Staff Report

To: Salt Lake City Planning Commission
From: Eric Daems, Senior Planner, eric.daems@slcgov.com, 801-535-7236
Date: August 10, 2022
Re: PLNPCM2022-00327, The Collaborative

Design Review

PROPERTY ADDRESS: 1135 South West Temple Street
PARCEL ID: 15-12-431-002-0000
MASTER PLAN: Central Community
ZONING DISTRICT: CC Corridor Commercial

Prepared by: Landscape Plan

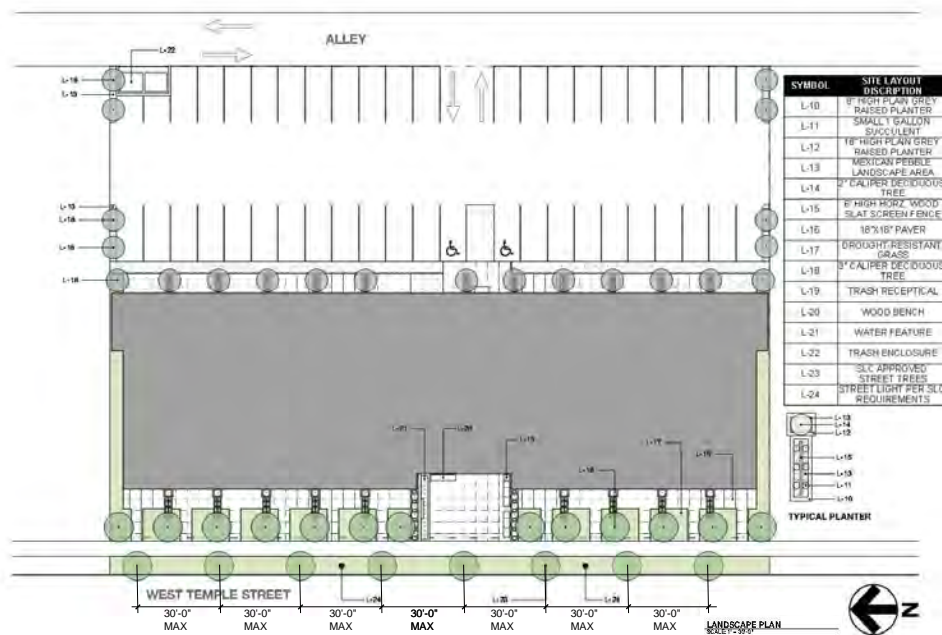
These preliminary plans look acceptable to Urban Forestry standards. I have just a couple of clarifying notes. On the final plans that are submitted for review, the eight parkstrip trees shown along West Temple St will need to be identified with a specific species that will remain small at maturity due to the overhead powerlines. I have attached a list of recommended species that will be appropriate for this location. I have also included several documents that describe information that we are looking for in our Urban Forestry reviews. One other reminder, all plans that propose new tree plantings in the public ROW will require a Tree Planting permit from the Urban Forestry Division prior to the approval of the building permit.
